JOINT REGIONAL PLANNING PANEL
(Sydney West Region)

JRPP No	2011SYW128
DA Number	DA/1305/2011
Local Government Area	Hornsby
Proposed Development	Demolition of existing dwellings and construction of an Affordable Housing development comprising 46 dwellings
Street Address	7, 9 & 11 Hannah Street and 129-131 Copeland Road, Beecroft
Applicant/Owner	Uniting Care Ageing – Sydney / The Uniting Church in Australia Property Trust (NSW)
Number of Submissions	238 – Original Proposal 30 – Amended Proposal
Recommendation	Approval
Report by	Garry Mahony – Senior Town Planner

Assessment Report and Recommendation

3.2.5 Solar Access

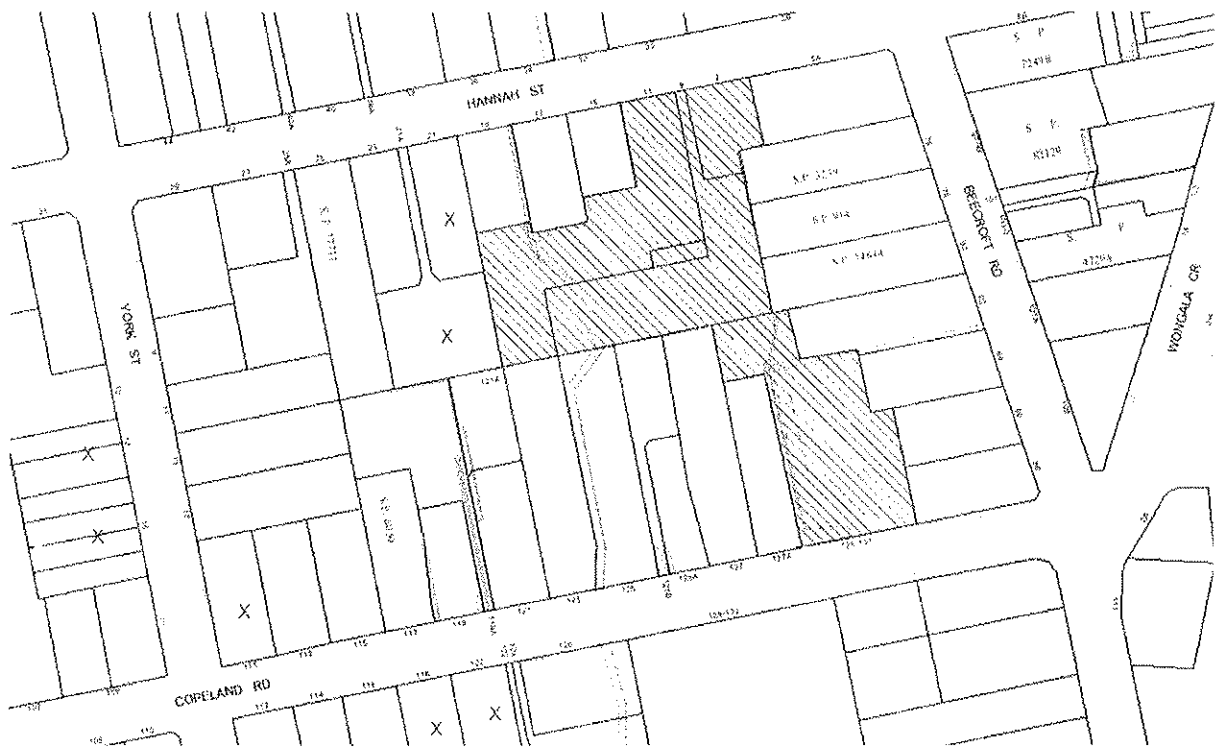
The proposed development complies with *Code* requirement for a minimum of 70% of dwellings to receive three hours of sunlight between 9am and 3pm on 22 June.
